Report - Standing Policy Committee on Property and Development - July 18, 2005

Item No. 2 Subdivision and Rezoning - east side Main Street, north and south of Commonwealth Avenue (Coral-Reef Holdings Ltd.)
File DASZ 11/2005

Date: June 6, 2005
File: DASZ 11/05
Related Files: DASZ 10/05
Subject: An application has been received from Dave Palubeski, Lombard North Group for approval of a plan of subdivision and related zoning change to Zoning By-Law No. 6400/94 by rezoning the subject lands from a "R1-20" Residential District to "R1-4" Residential District and "PR-1" Parks and Recreation District to allow for the creation of single family lots and public reserve land.

Figure 1: ROW and Easement Across Proposed Extension to Rivergrove Drive

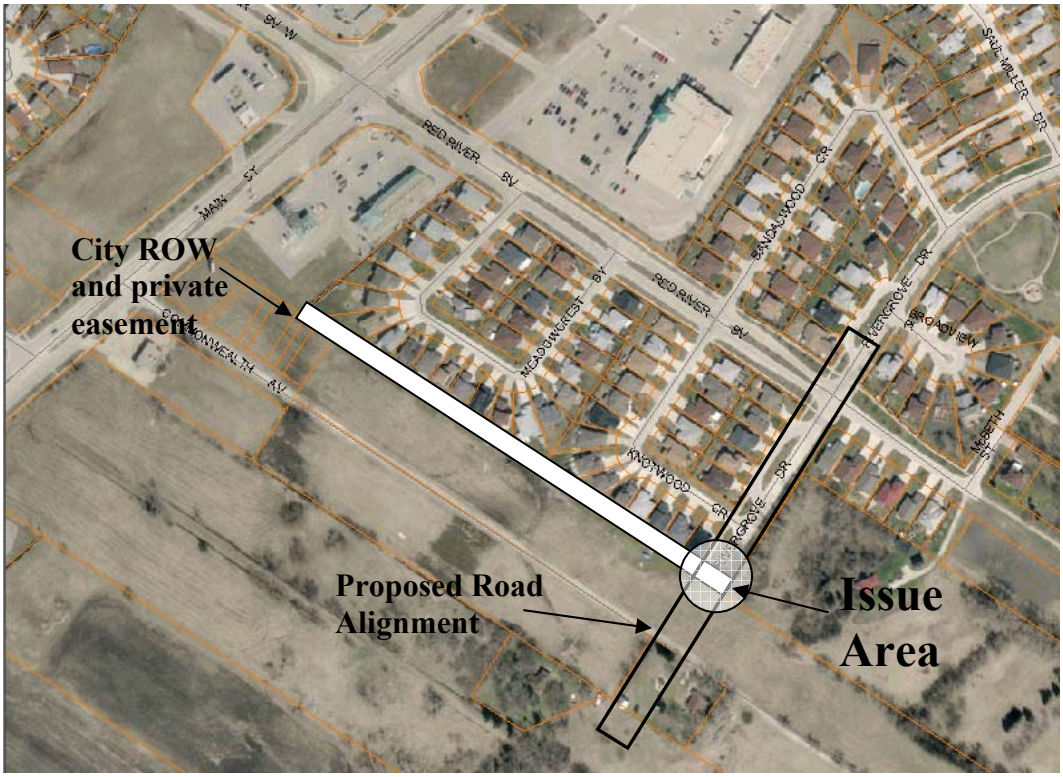
In order to construct the southerly extension of Rivergrove Drive, which would connect with Main Street via a proposed new signalized intersection, a portion of an existing city-owned right-of-way, where it intersects with the proposed Rivergrove Drive right-of-way, is required to be opened as a street.

At the same time, an adjacent property owner who is not a party to this application, holds an all-purpose easement across this right-of-way. In order for the street to be opened across this easement, the easement holder must agree to withdraw the easement, which the applicant has indicated has not occurred. Without agreement from this individual, this land cannot be opened at a street –preventing the crucial connection with Rivergrove Drive to the north and eliminating an essential second point of access to both this development and that to the south.

Given the fact that this individual is not party to the application, any conditions requiring modifications to his land holdings may be impossible for the applicant to satisfy.
